World Forum for Harmonization of Vehicle Regulations

Proposal for Supplement 3 to the original series of amendments to UN Regulation No. 150 (Retro-reflective devices)

Submitted by the Working Party on Lighting and Light-Signalling*, **

Figure A24-II
Simplified marking examples for grouped, combined or reciprocally incorporated devices

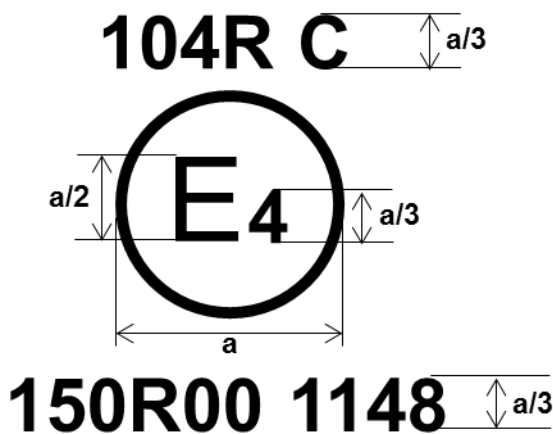
Annex 24, amend to read:

Note: The two examples of approval marks, models D and E, represent three possible variants of the marking of a lighting device when two or more lamps are part of the same unit of grouped, combined or reciprocally incorporated lamps.
